| RE: | MSA-1 PCIs 020 and PCI 023 |

POTENTIAL CHANGE ITEM

PCI020

TITLE: Roof Deck Coatings
PROJECT: Magnolia Science Academy

Pictures of the Parking Lot Pavement

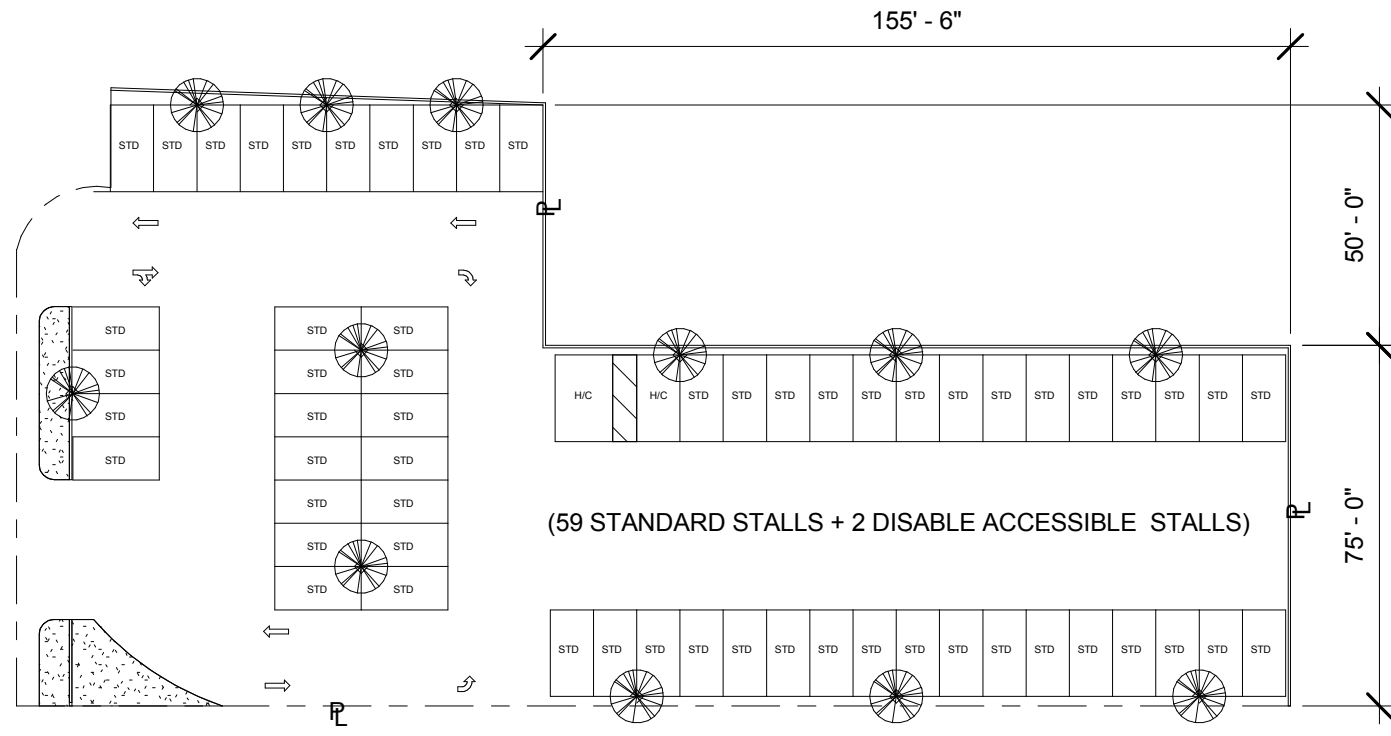
As shown previously and evidenced by the pictures attached hereto as Exhibit B, the parking lot pavement is in such bad shape that a slurry and seal approach will not guarantee any longevity and no installer will guarantee the work. The pavement could very well require replacement in 1, 2 or 3 years, resulting in wasted money. The only scope included in Oltmans’ original bid was to slurry and seal the parking lot. The thinking behind this approach was that if the adjacent ice skating rink ever came to fruition as a collaboration between MSA-1 and City Parks and Rec and the rink was placed on both MPS’s property and City property, then anything in the way would be ripped up and the City would pay for the work. At this stage the City has produced a plan to build the rink without using MSA-1 property. See Exhibit C. While the Council office has expressed their interest in creating a rink that would be positioned on two parcels, one of which would be MSA-1’s property, so far it far from certain. Therefore Staff believes it would be prudent to plan for a long term solution for the parking lot.

This Potential Change Item (PCI) tracks costs associated with the added labor, materials, and equipment required to install new paving in lieu of seal and slurry. Seal and slurry and/or grind and overlay are not recommended or guaranteed by the asphalt paving trade due to existing conditions. The existing pavement is on native, the estimated life of grind and overlay would be limited.

Staff recommends that the entire parking lot be repaved. The total cost, with credits is **\$96,952**. Staff has been carrying an allowance for site work of \$125,000. Therefore, the overall budget will not be impacted and there may be some savings realized. A copy of PCI 023 is attached as Exhibit D.
